CITY OF PARKER

PUBLIC NOTICE

RE: 1110 GERMAINE STREET SHORELINE CONSTRUCTION AND DREDGING PERMIT – 19-285

Subject: 1110 GERMAINE STREET SHORELINE CONSTRUCTION AND DREDGING PERMIT – 19-285

HOFLUND FAMILY DOCK

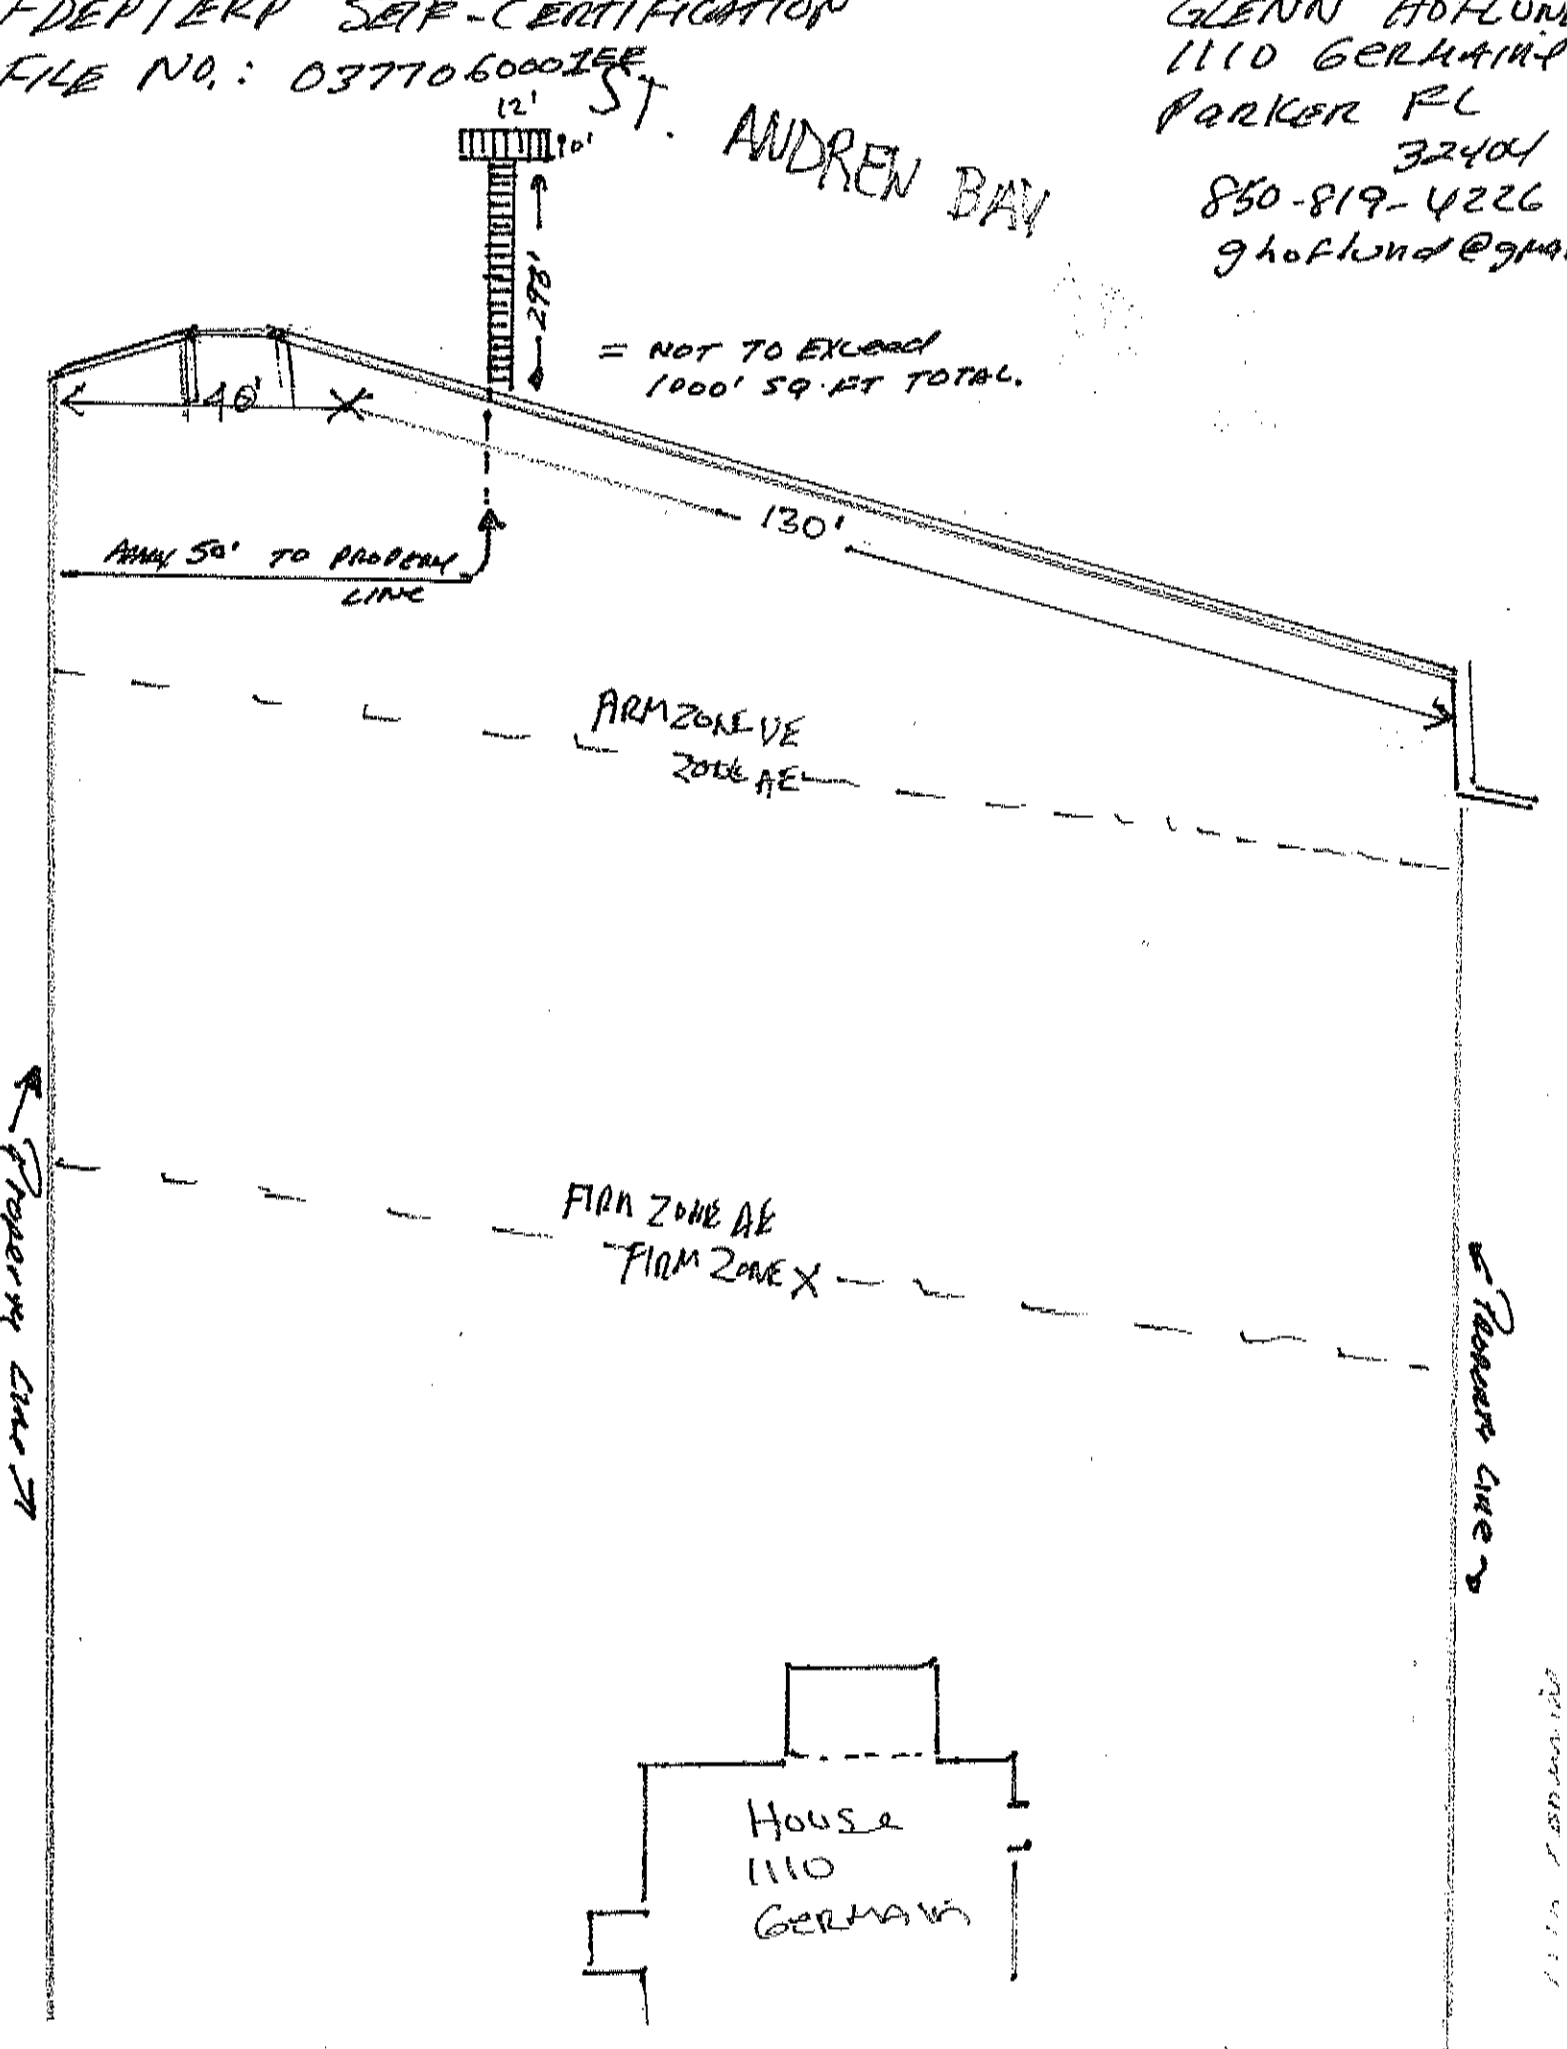
1. Living quarters or dwelling: No
2. Dock Area: > 1,000 square feet
3. Setbacks (Chapter 18-21.004(3)(d), F.A.C.)
 - Lot width: 170 feet
 - Minimum setback: 50 feet
 - Infringes on riparian right lines: No
4. The dock will be required to meet all applicable State and Federal requirements.

- The structure will be required to meet all applicable State and Federal requirements.
